# Applicant Outreach Summary

Outreach Summary LOC2022-0116 | 528 & 628 10 ST NW 3

### BUILT FORM REVISION

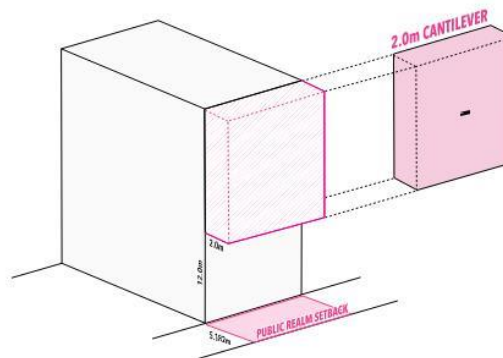
The HSCA and two respondents provided feedback to the project team regarding the built form, including the cantilever and the potential impacts to privacy and shadowing on adjacent properties. The HSCA and one respondent provided support for the proposed building height as it contributes to greater density.

The project team proposes to maintain the proposed building height of max. 26m; however, the 2m cantilever that previously extended over the public realm setback along 10 ST NW has been eliminated, which will in turn minimize shadowing and overlooking concerns for adjacent neighbours. The project team architect also strategically limited the size and placement of windows on the buildings' side facades to minimize privacy concerns. Additional revisions to the concurrent Development Permit may be integrated as it undergoes further evaluation by the Development Authority through the Development Permit review process.

*Elimination of 2m Building Cantilever over Public Realm Setback*
